TECHNISCHE MITTEILUNG
TECHNICAL NOTE

Nr: 205-4 e

Reference: Sailplane model Club Libelle 205
German Data Sheet Nr. 304, all Serial Numbers

Subject: Mounting attachment of the airbrake hinges

M2:1	Rohrriet für BK	205-56-62	26.2.75 JG
--	------	-----------------	-----------	------------

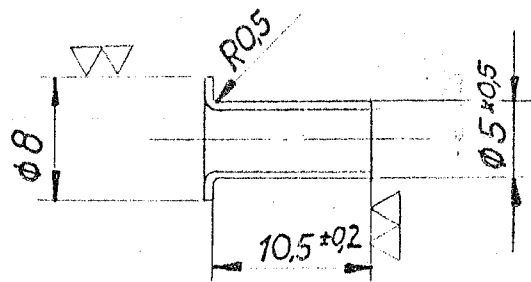
Method: The attachment screws M 5 x 14 according to specification LN 9037 with hexagon nuts M 5 according to specification LN 9348 and washers 5,3 according to specification DIN 9021-St of the airbrake hinges in the wing are replaced by tubular rivets according to drawing 205-56-62 and washers 5,3 according to specification DIN 125-St.

Stirnflächen entgratet

gefertigt aus Rohr 5x0.5x13.5 1.4571 DIN 2464
